# UNITED STATES PATENT AND TRADEMARK OFFICE

| APPLICATION NO.  | FILING DATE | FIRST NAMED INVENTOR | ATTORNEY DOCKET NO. | CONFIRMATION NO. |
|--|-------------|----------------------|---------------------|------------------|
| 10/602,930   | 06/24/2003  | David Ernest Hartley | PA-5332-RFB         | 1860             |

**Office Action Summary**

FIG. 19

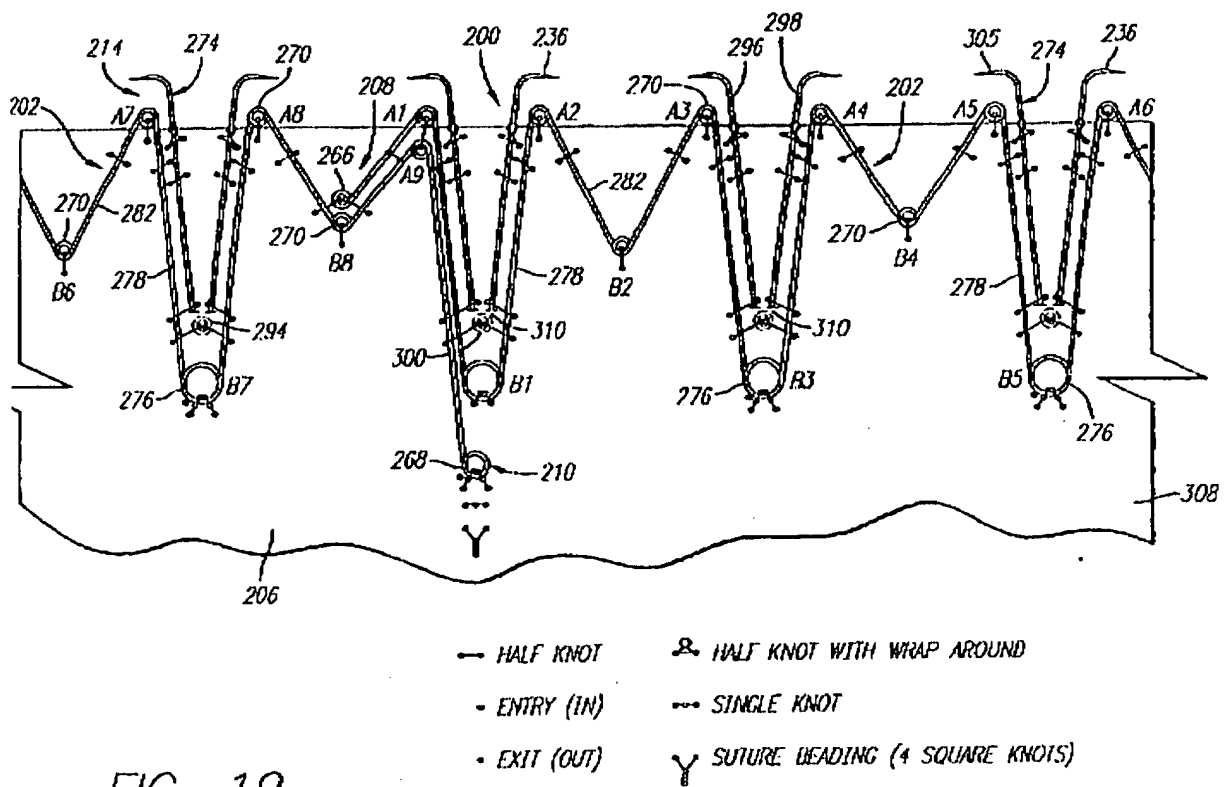
Baker et al discloses a 1 medical device comprising: a graft material, stent affixed to and extending from the graft material, the stent comprising plurality of struts and bends between them, the bends defining apices, and at least two spaced apart fastenings affixing the stent to the graft material, each fastening including at least one turn of an elongate flexible fiber through the graft material and around a portion of the stent wherein a first of the at least two spaced apart fastenings is laced at the apex and a second of the at least two spaced apart fastenings is laced adjacent the transition from the bend to the strut. See figure 19.

Applicant argues that Baker, et al fails to illustrate a stent which is "affixed to and extending from the graft material". Examiner disagrees with applicant's arguments, the scope of the arguments does not preclude a portion of the stent extending from the material. Moreover, the claim fails to positively define the stent as extending beyond the edge of the graft and, in fact, the stent of Baker may be interpreted as extending from the graft even though being covered by the same. Accordingly, the claim as broadly worded is fully anticipated by the graft/stent combination of Baker, et al.

Claims 3,5,6,7,8,9,22 and 23 do not distinguish over the same as disclosed by Baker, et al. Claim 3, see various knots arrangements, including single, square and half knots. Claim 5, see column 19, lines 14+. Claim 6, see column 23, lines 4+. Claim 7, see column 10, lines 5+. Claim 8, see column 7, lines 1+. Claim 9, see columns 10 and 11. Claims 22, the manner by which the stitches are placed on the graft does not impart further structural distinction over the same as disclosed by Baker, et al. Claim 23, see figure 19 supra.
